**SIB 61 06 25****GEN5 BEV "DRIVETRAIN" CHECK CONTROL MESSAGE / FAULT 224188 STORED**

This Service Information bulletin (Revision 1) supersedes SI B61 06 25 **dated May 28, 2025.**☐ THIS REPAIR IS MOBILE FRIENDLY**What's New:**

- SIB title revised
- BEV models added
- Cause updated; High Voltage warning revised
- Correction revised
- Parts Information updated
- Claims Information updated

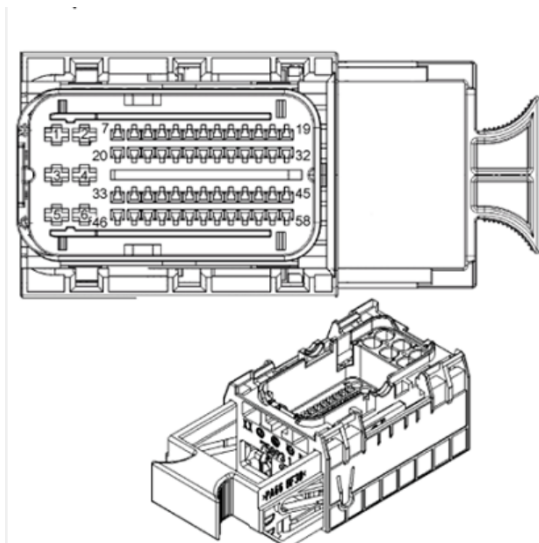
Plug IN and OUT the connector N8*1B several times (at least three times). The connector must be locked in place completely each time in effort to scrape and clean the corrosion coating from the pin contact surfaces.

Note: It is important to make sure the connector is fully disconnected and then reconnected for the process to be effective

Retest the vehicle after the procedure to verify the repair.

If the pins are found to be faulty, replace the following contact pins 40, 41, 42, 53, 54, 55 for the CCU low voltage (12 V) wiring harness connector (N8*1B) with pin part number 61 13 6 820 598 (bushing contact MLK 1.2 (0.50 mm²/AG.50 mm)).
